Sub Regional RTEP Committee South

January 05, 2017

B2654.1 - .4 Cost Increase and Scope Modification

B2654.1 - .4 Cost Increase and Scope Modification Continued

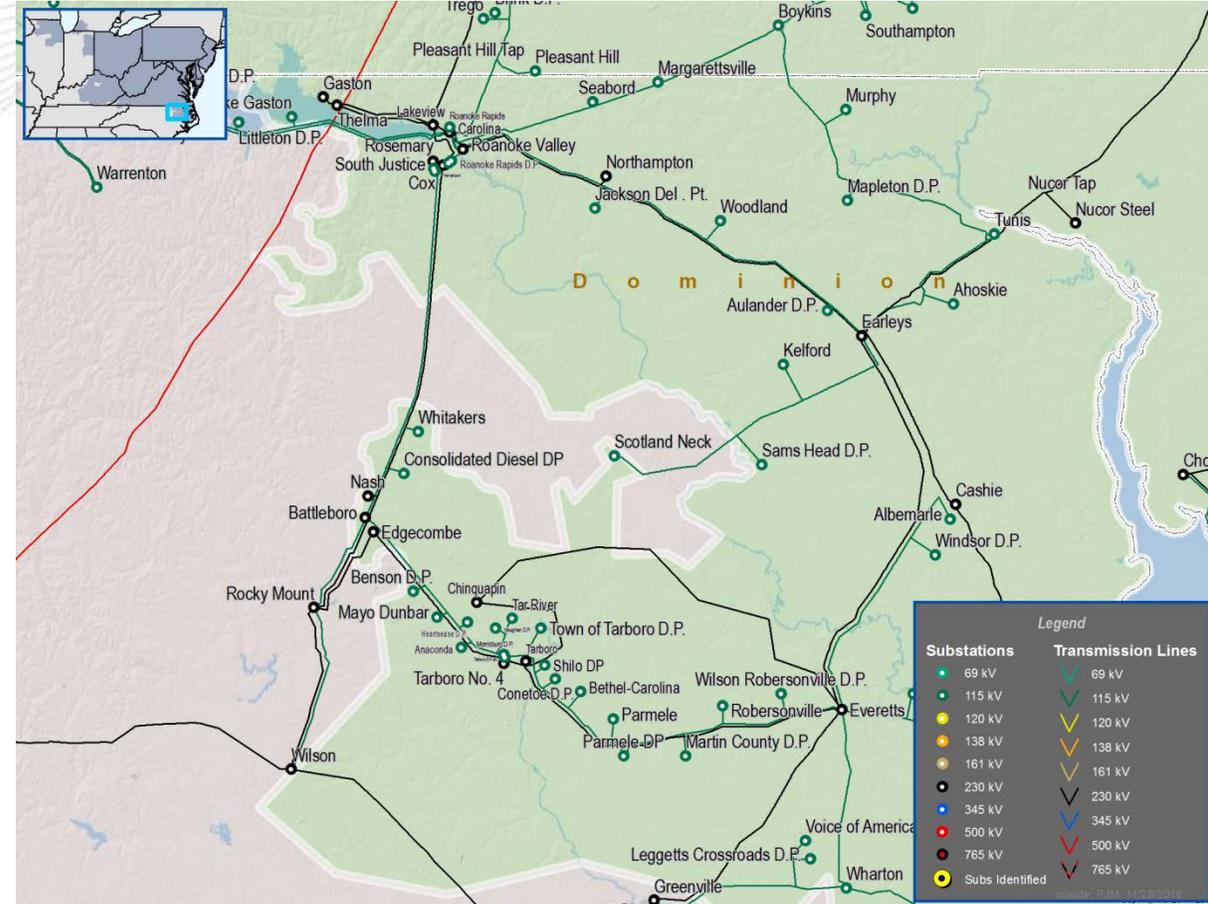
- Final routing increased the line mileage from 15 to 16 miles from Scotland Neck to South Justice Branch.
- Summer emergency rating target changed to 346 MVA from 262 MVA.
- Install an additional 115kV breaker in the breaker ring at S Justice Branch for a total of four 115kV breakers in the ring for breaker failure reliability.
- The cost increase is due to refined detailed cost estimate updates and the increased line mileage for the final routing.

Previous Estimated Project Cost: \$ 33.0 M

Revised Estimated Project Cost: \$ 46.0 M

B2653.1 - .3 Cost Increase and Scope Modification Continued

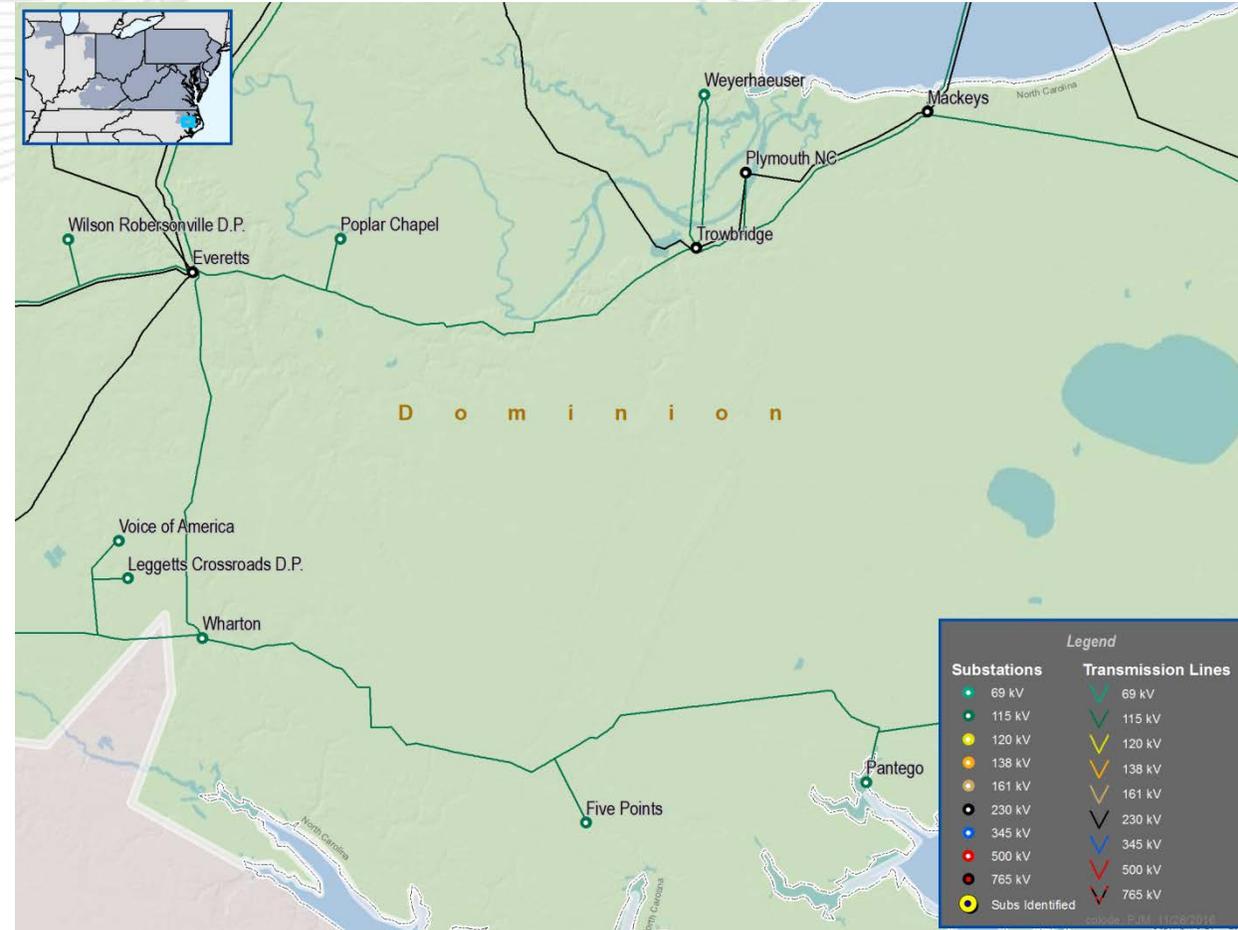
- Final routing increased the line mileage from 20 to 22 miles from Pantego to Trowbridge
- Summer emergency rating target changed to 346 MVA from 262 MVA
- The cost increase is due to refined detailed cost estimate updates and the increased line mileage for the final routing.

Previous Estimated Project Cost: \$ 35.0 M

Revised Estimated Project Cost: \$ 44.6 M

Existing B1794 Cost Increase

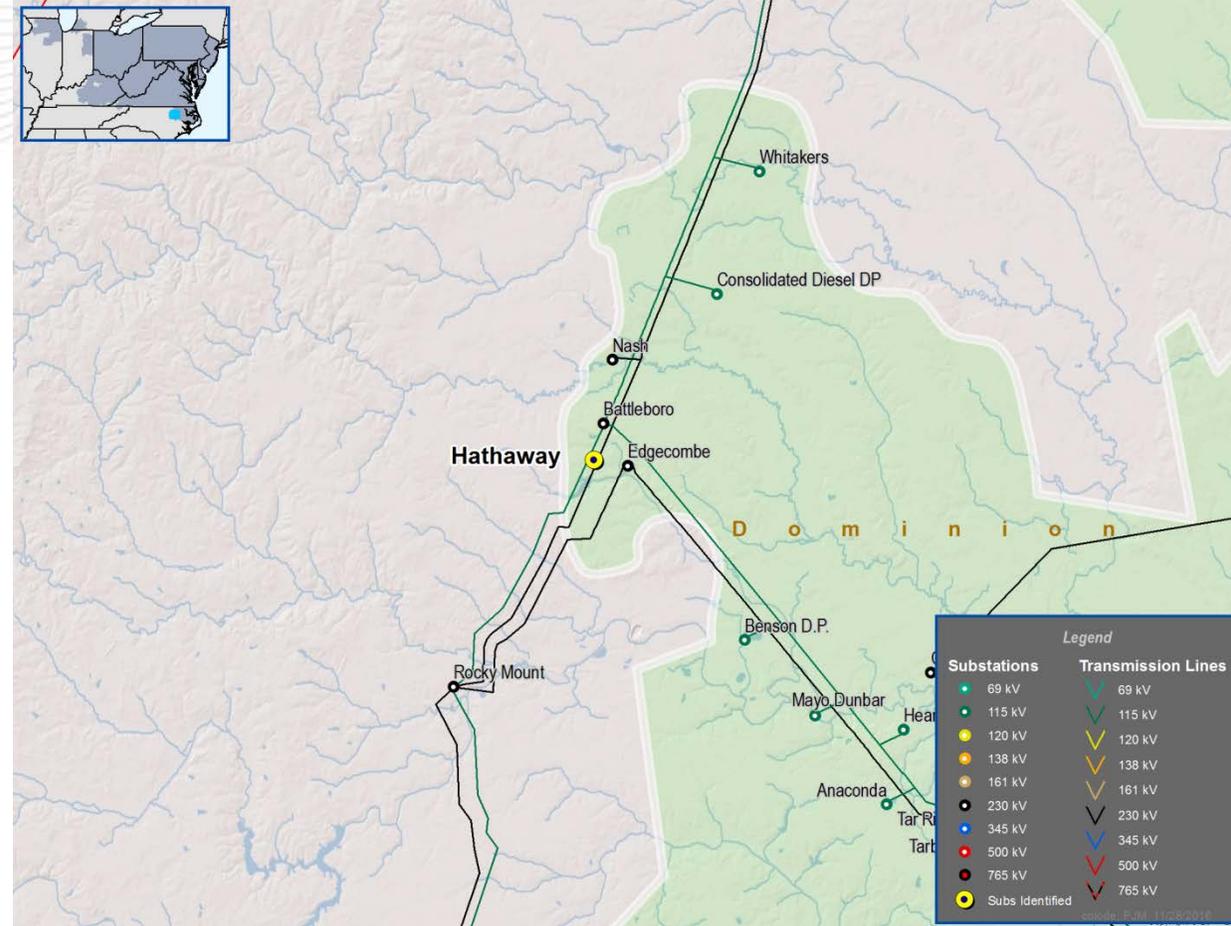
- The cost increase is due to additional substation expense, cost of land, expense for storm drainage and escalation of material and labor costs.

Previous Estimated Project Cost: \$ 19.0M

Revised Estimated Project Cost: \$ 25.4M

Existing S0610¹ Cost Increase

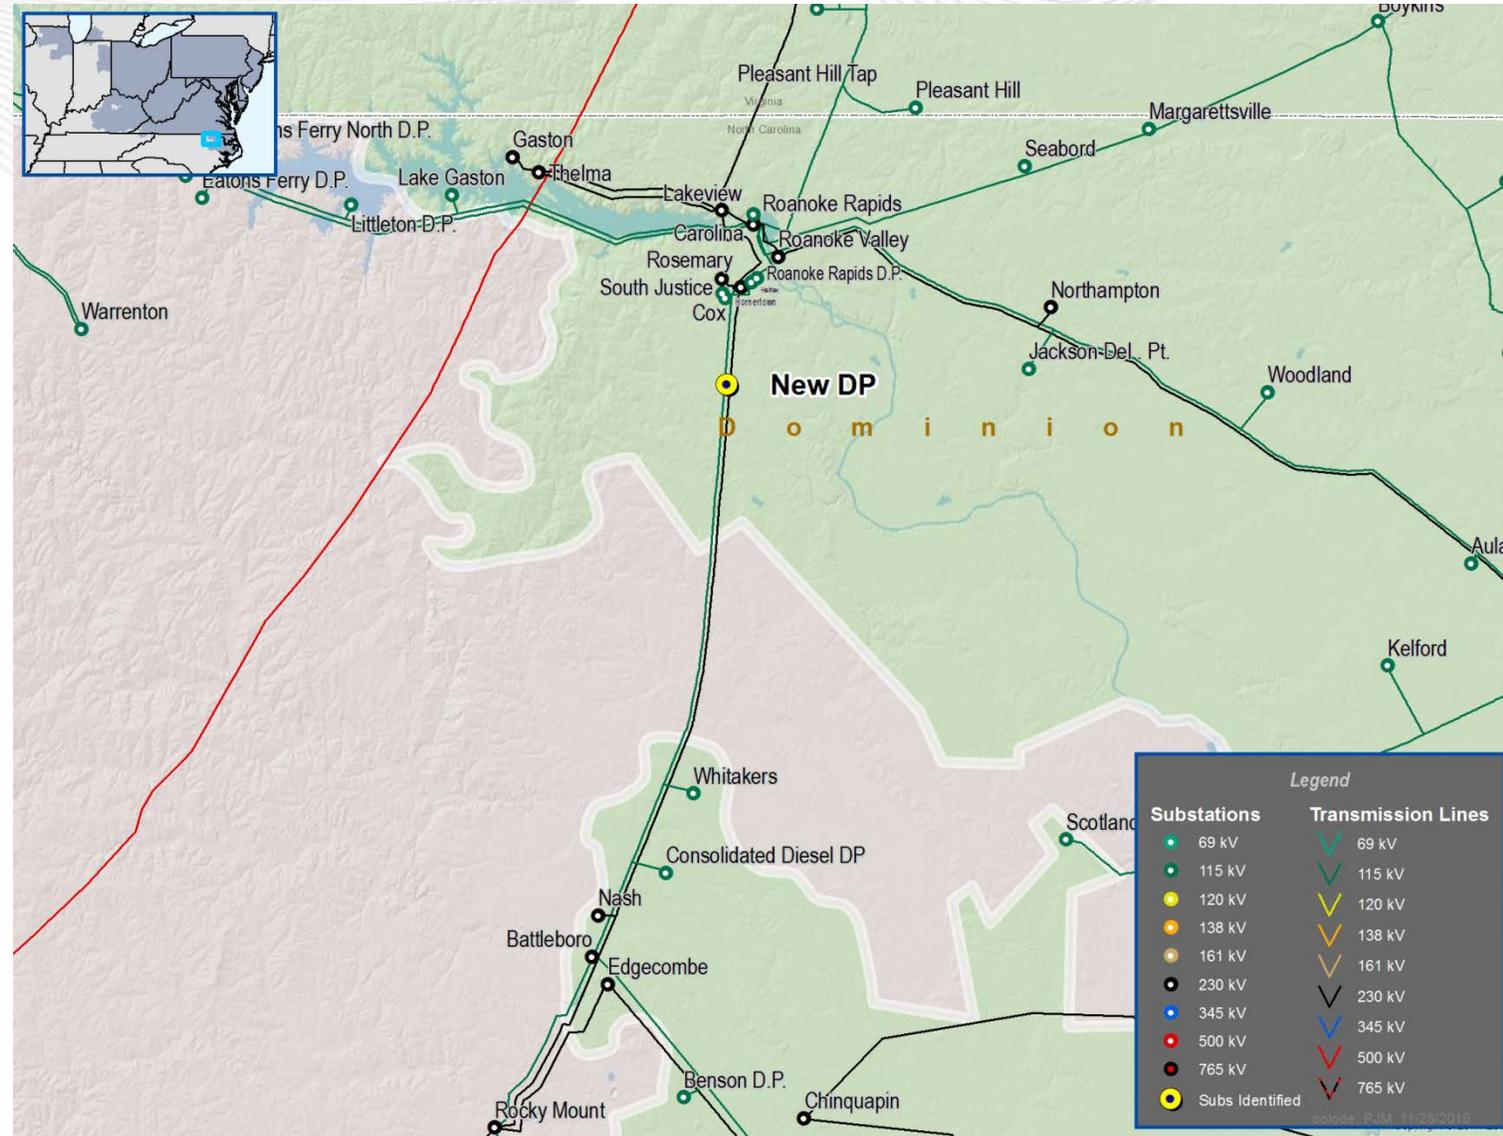
- Modification to the scope of work and timing of the Delivery Point
- Detailed estimated versus ballpark
- Retirement of Halifax DP switches

Previous Estimated Project Cost: \$ 0.6 M

Revised Estimated Project Cost: \$ 2.0 M
